**Agenda**  
**City of Springboro Planning Commission Meeting**  
**Wednesday, March 19, 2025, 6:00 p.m.**  
**Council Chambers, City Building, 320 West Central Avenue**

**Background Information & Staff Recommendations**  
**City of Springboro Planning Commission Meeting**  
**Wednesday, March 19, 2025, 6:00 p.m.**  
**Council Chambers, City Building, 320 West Central Avenue**

**A. Final Approval**  
**Record Plan, Eastbrook Farm, Section One**

### **Final Development Plan, Easton Farm PUD-MU, Planned Unit Development-Mixed Use, 605 North Main Street, multifamily component**

① ELECTRIC SITE LIGHTING  
1" = 40'-0"

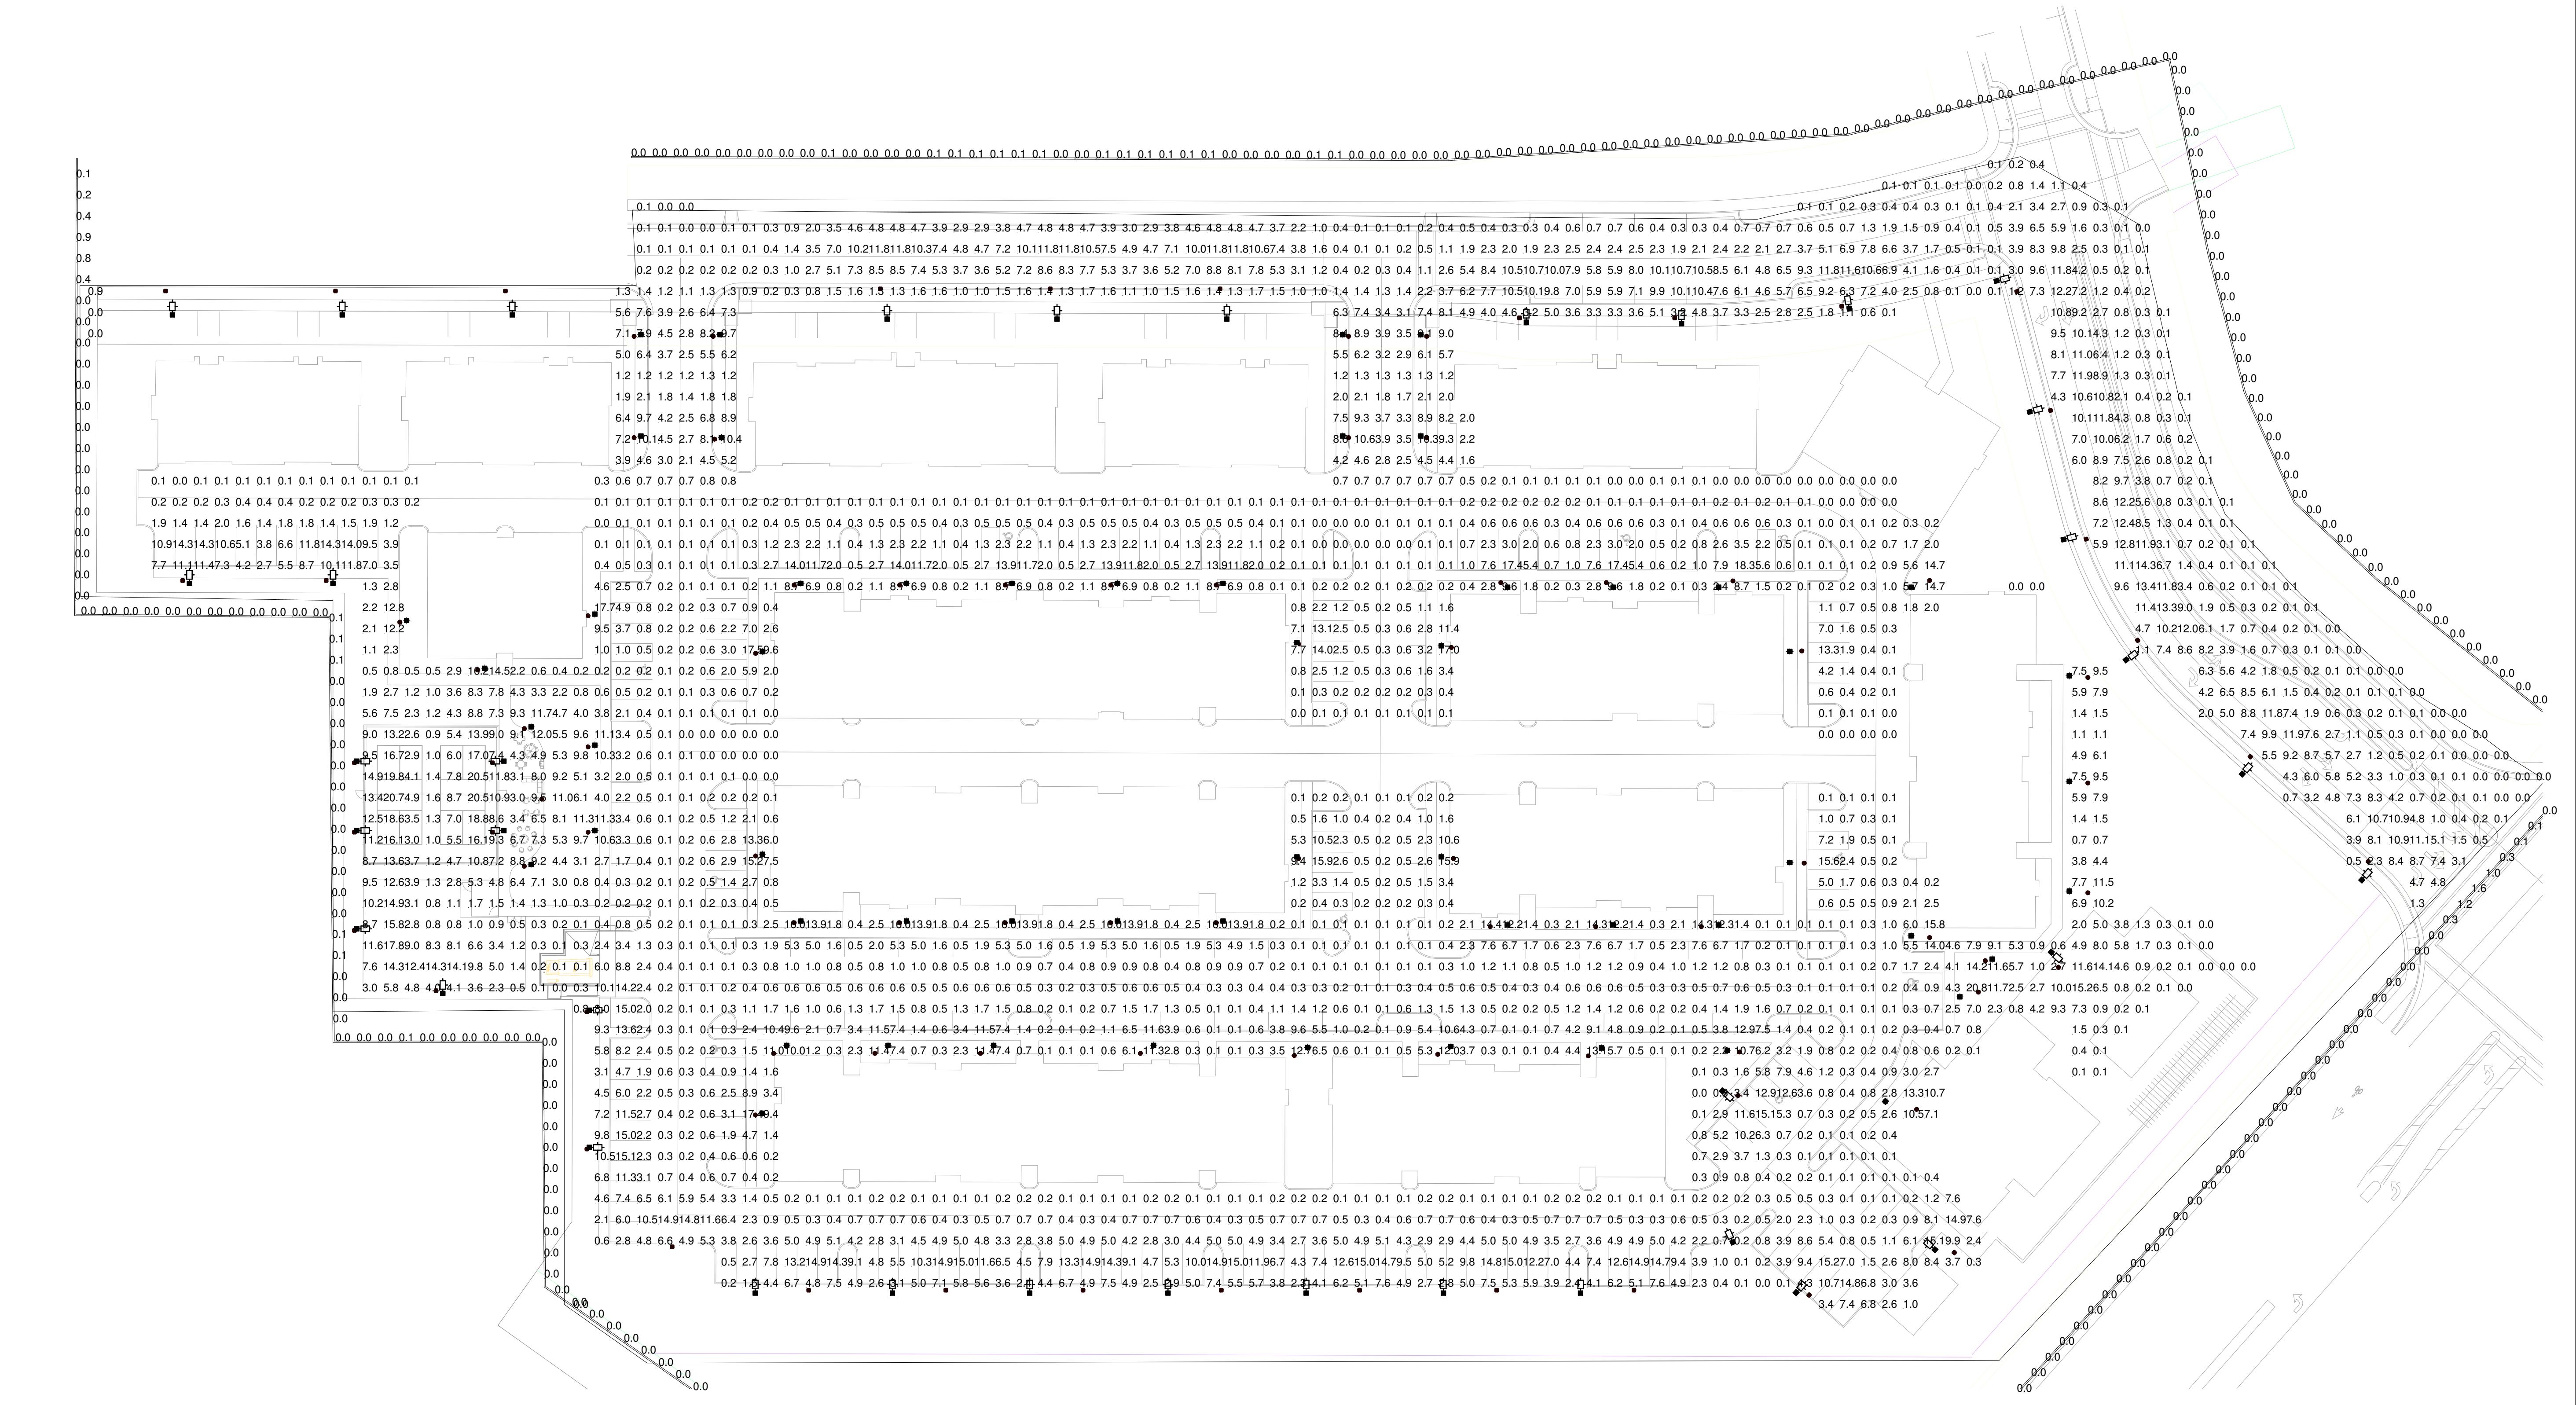
3. Identify common areas to be dedicated as part of this component of the PUD-MU. A minimum of 25% open space is required.
4. City staff to provide complete review of revised lighting plan submitted on March 11 under terms of Chapter 1273, Exterior Lighting. Meantime, the following is to be noted:

- c. City staff recommends using fixtures with IDA (International Darksky Association) certification.
5. Following preliminary review of final development plan, submit a signage plan consistent with Chapter 1281 of Planning and Zoning Code.
